MICHIGAN STATE UNIVERSITY

SUBJECT: Docket 50-294, Formal Review Questions--Your Letter Dated
May 11, 1984

Michigan State University
 Docket 50-294 Formal Review Questions, MSTR
 (Reference: NRC Letter Thomas → Wilkinson 5/11/84)

Figure 6. Detector Ranges

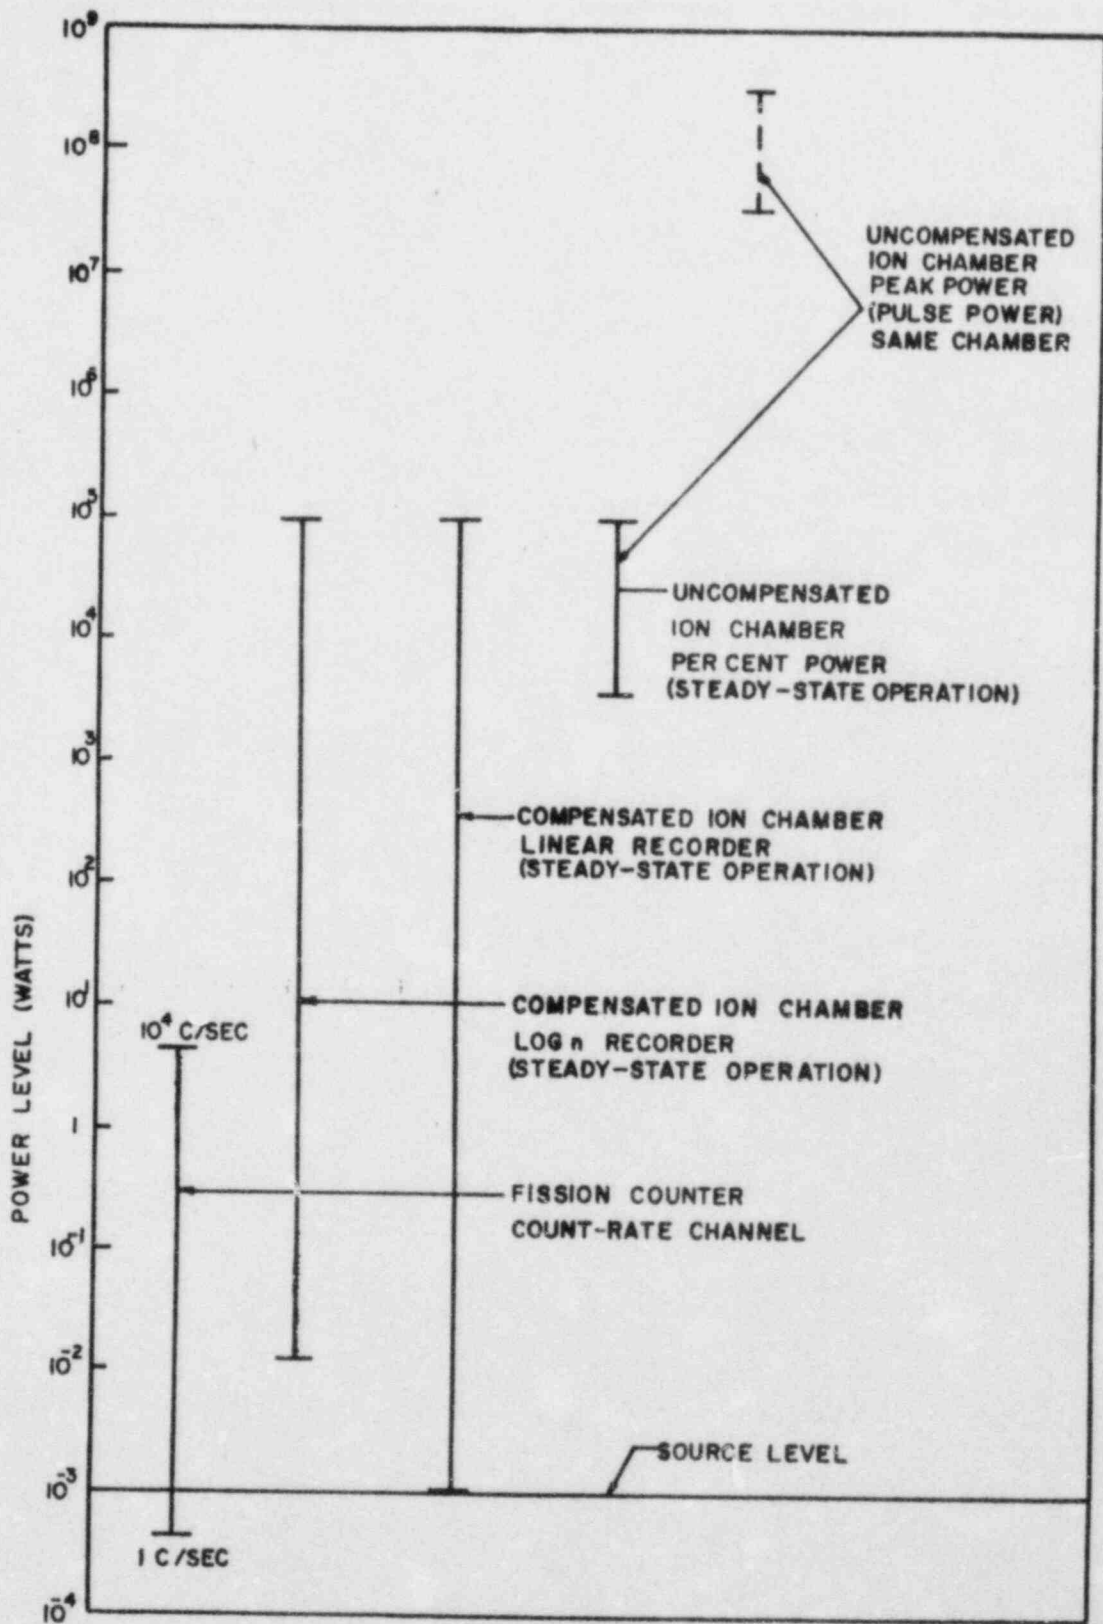
44. Provide a bar chart drawing of the operating ranges of the in-core nuclear detectors.

Figure 6 is a graph of the detector ranges for the MSTR.

Figure 6 is a bar chart of the operating ranges of the detectors.

Fig. 7. Transient-rod drive mechanism

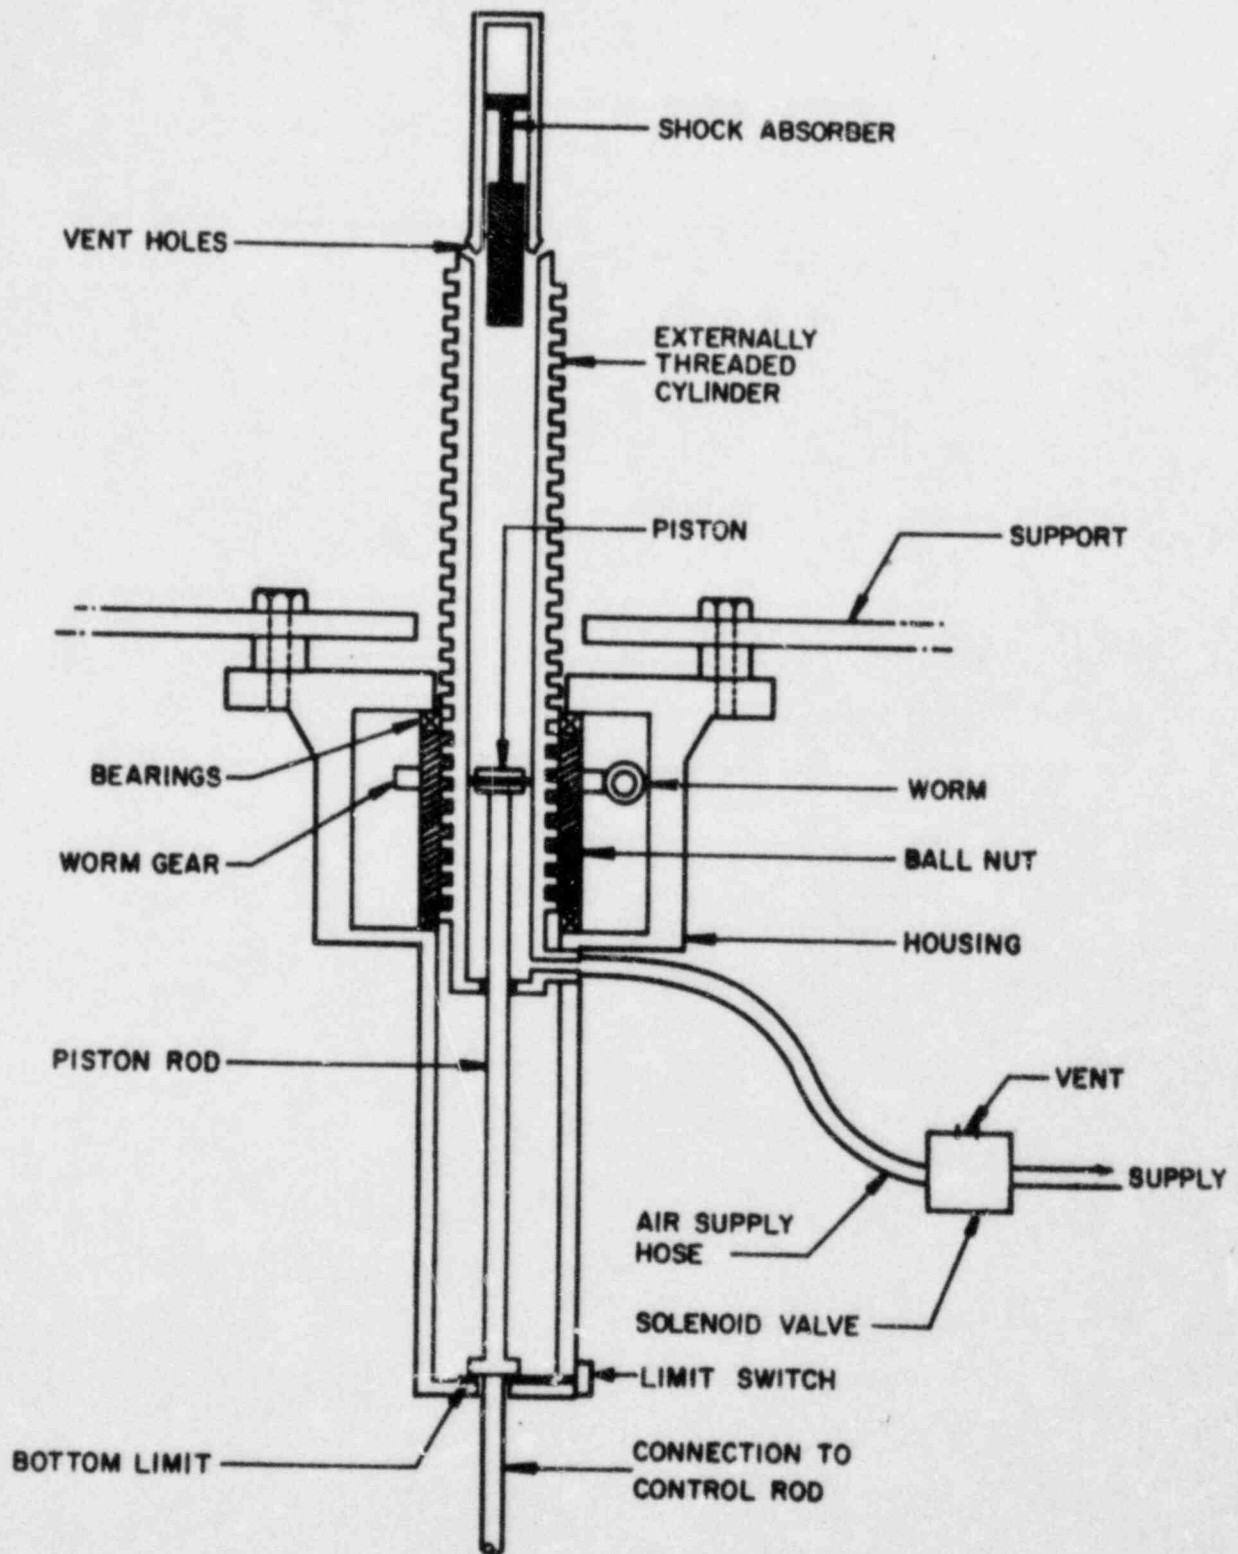
54. Describe in detail the transient rod pneumatic drive system and the system operation in the pulse, scram and manual modes. Address the absence of an electromagnet.

Figure 7 details the rod drive mechanism for the pulse rod. Operation of the pulse rod is controlled from the console.

Figure 8. Floor Plan for Reactor Room, scale 1/8" = 1 foot.

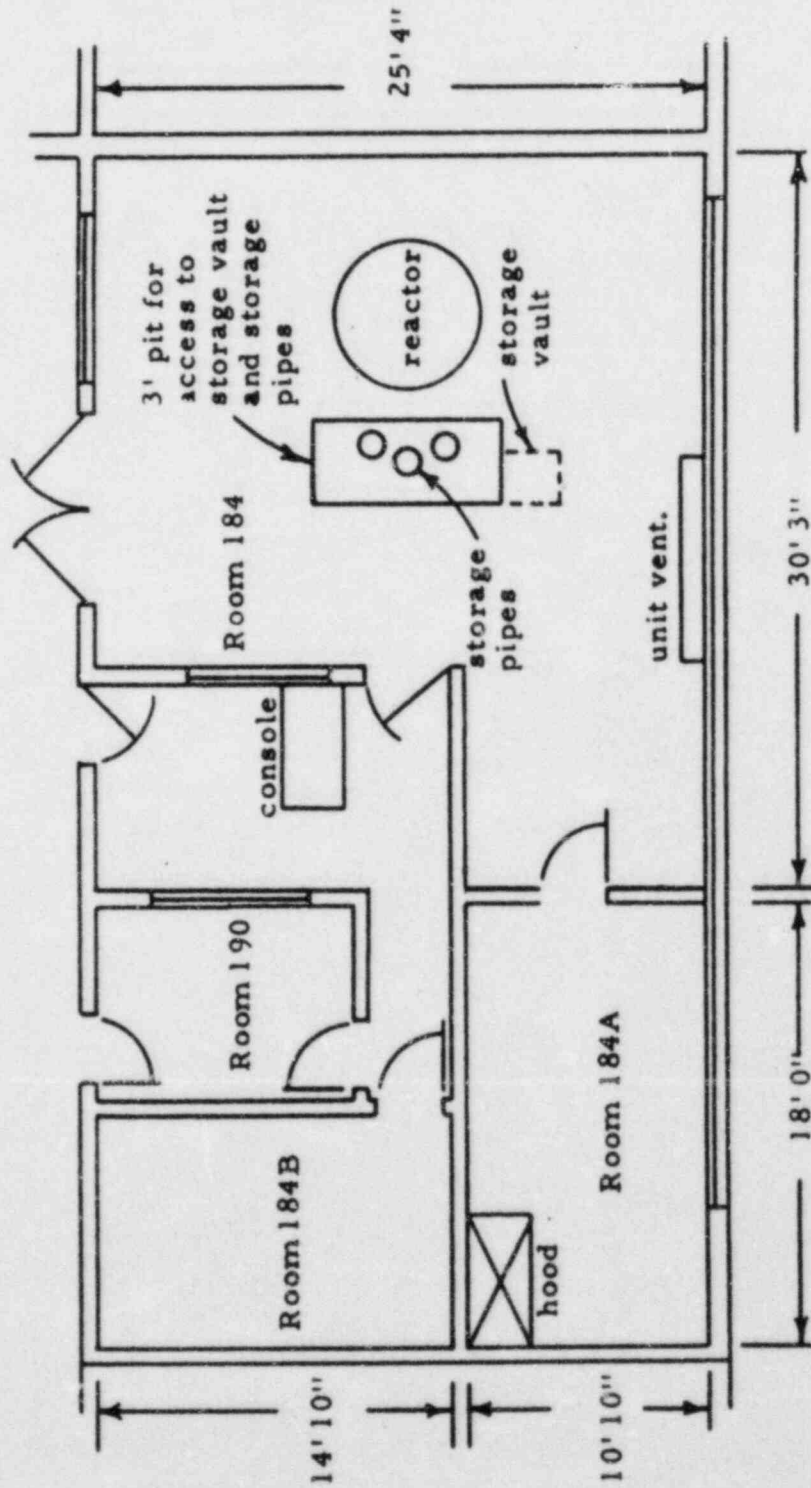
57. Please provide clear, reproducible MSTR figures for the following:

1. Figure 8
2. Figure 1
3. Figure 9
4. Figure 10
5. Figure 2
6. Figure 2
7. Figure 3
8. Figure 7
9. Figure 5A
10. Figure 5B
11. Figure 5A and B
12. Figure 11
13. Figure 5A
14. Figure 2
15. Enclosed 1 copy. Figure 12.
16. Enclosed 1 copy. Figure 13.
